Project Name: **Haverhill Consentino Middle School** PCO No.

Architect's Project No. **21-0818**

Subject: **PR-86 Stairwell Soffit Paint** PCO Issue Date: **2026.01.13**  
 PCO Reviewed: **2026.01.13**

## PROPOSED CHANGE ORDER

JD-  
138

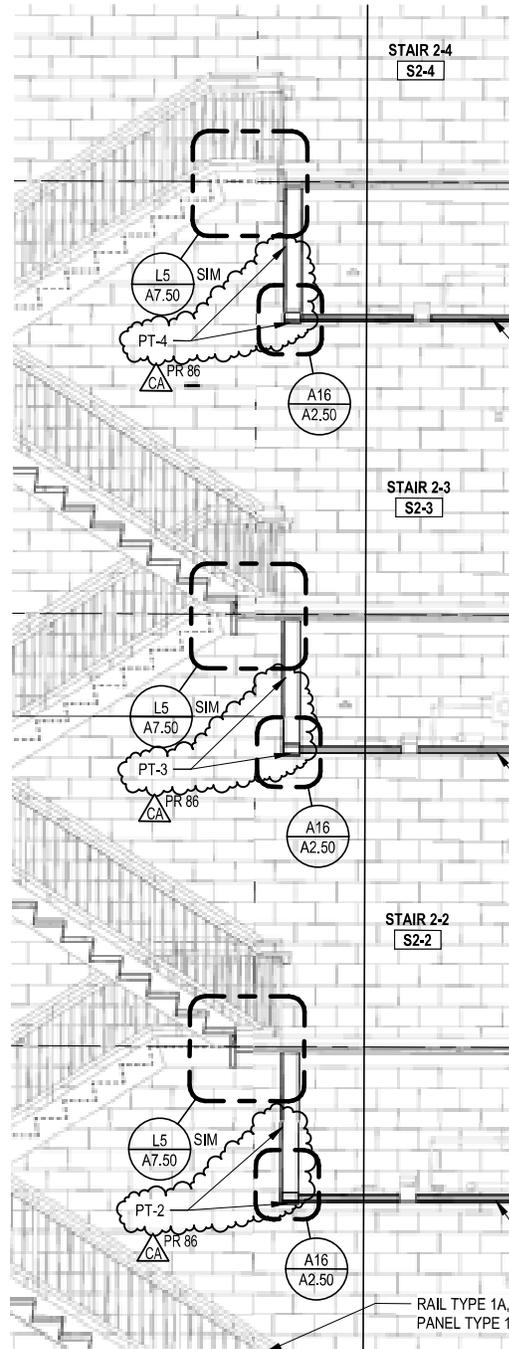
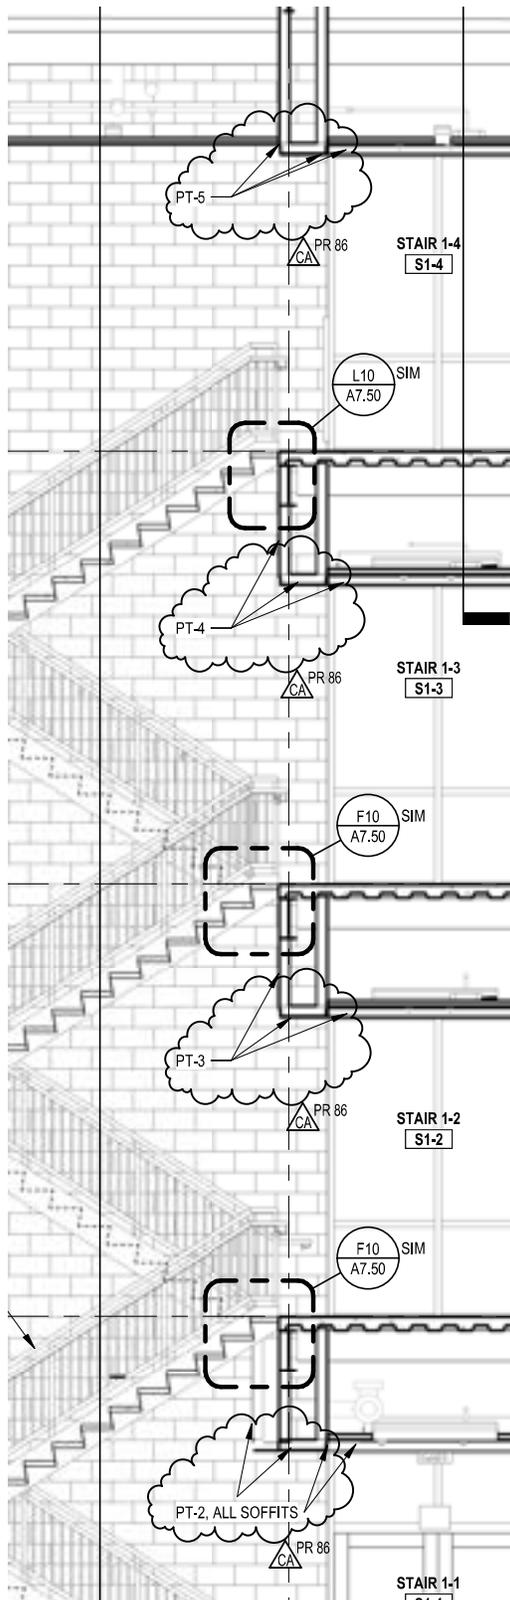
Contractor to provide pricing for accent paint at Stairwell soffits as shown on attached sketch **JD-138**. Make similar revisions to Stair 3 and Stair 4.

**A8** ENLARGED STAIR SECTION - STAIR 2, STAIR 3 SIM  
1/4" = 1'-0"

**A7** ENLARGED STAIR SECTION - STAIR 1  
1/4" = 1'-0"

JD-  
 139

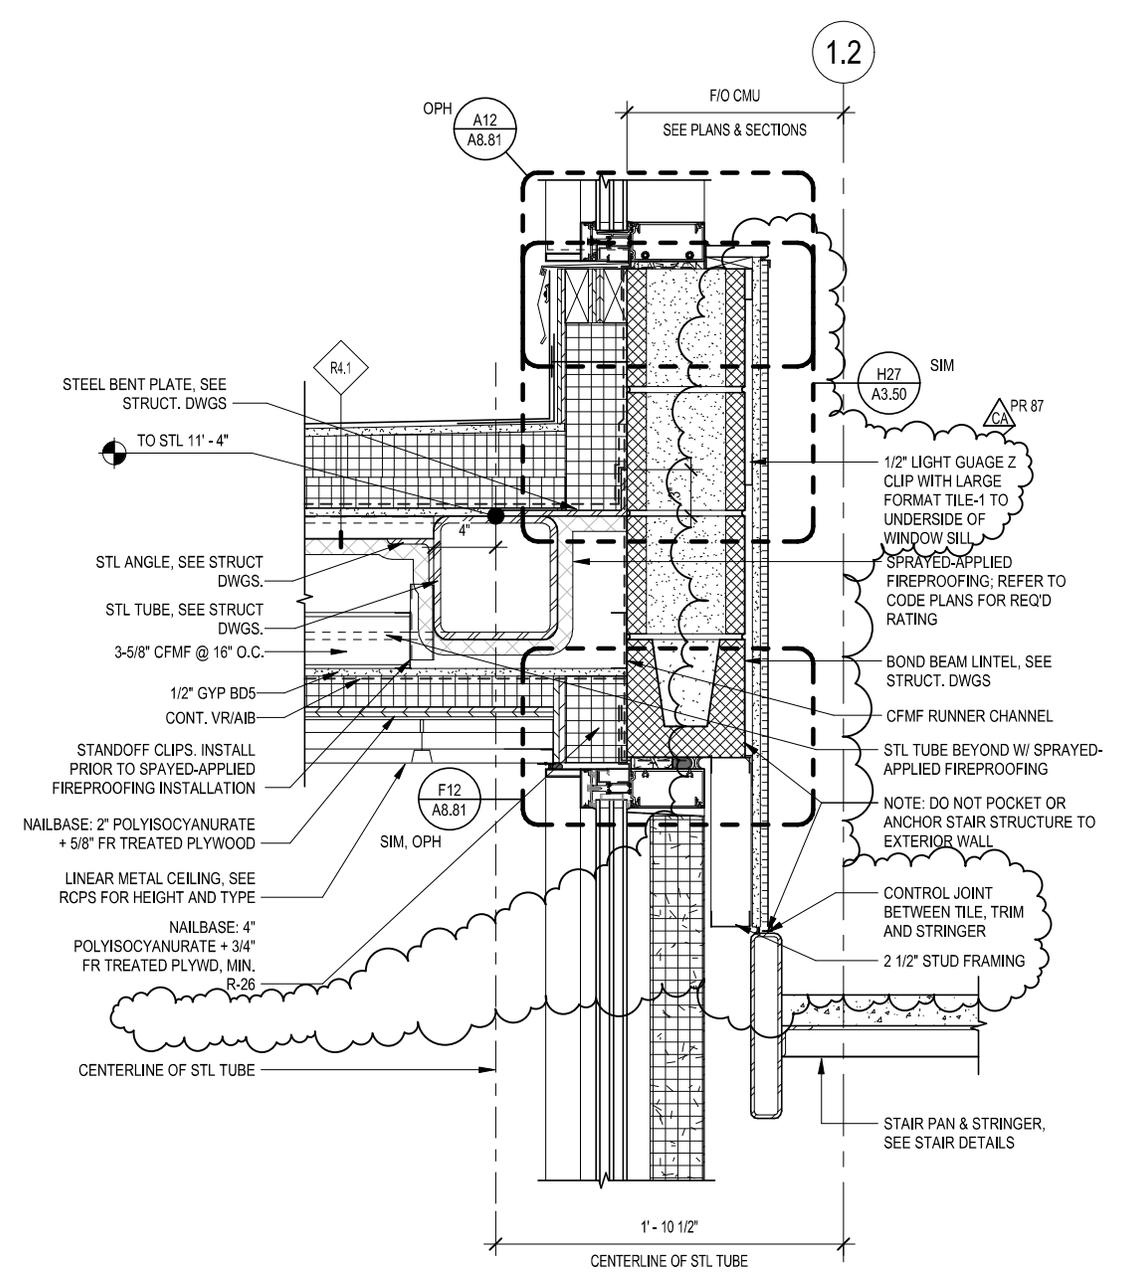
At Sheet A6.55, revise detail between landing and curtain wall sill (Q15) as shown on attached sketch **JD-139**.

**Q15** MID WALL - STAIR 2 CANOPY (STAIR 3 SIM)  
 1 1/2" = 1'-0"
